What to expect in the 2007

# NFPA 780

Standard for the Installation of Lightning  
Protection Systems

John M. Tobias, Ph.D., P.E.

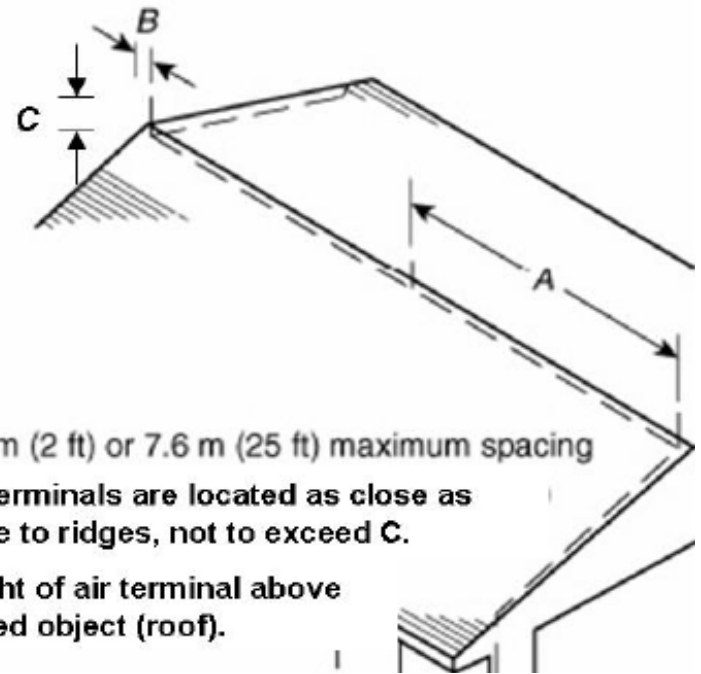
Proposal to decrease termination to edge interval revisited. (Accepted in Principle.)

- A: 0.6 m (2 ft) or 7.6 m (25 ft) maximum spacing
- B: Air terminals are located within 0.6 m (2 ft) of ends of ridges

- A: 0.6 m (2 ft) or 7.6 m (25 ft) maximum spacing
- B: Air terminals are located as close as possible to ridges, not to exceed C.
- C: Height of air terminal above protected object (roof).

Change 4.8.2 to read as follows:

4.8.2\* Location of Devices. As shown in Figure 4.8.2, the distance between strike termination devices and ridge ends on pitched roofs or edges and outside corners of flat or gently sloping roofs shall not exceed 0.6 m (2 ft).

A.4.8.2 Strike termination devices should be placed as close as practicable to roof edges and outside corners.
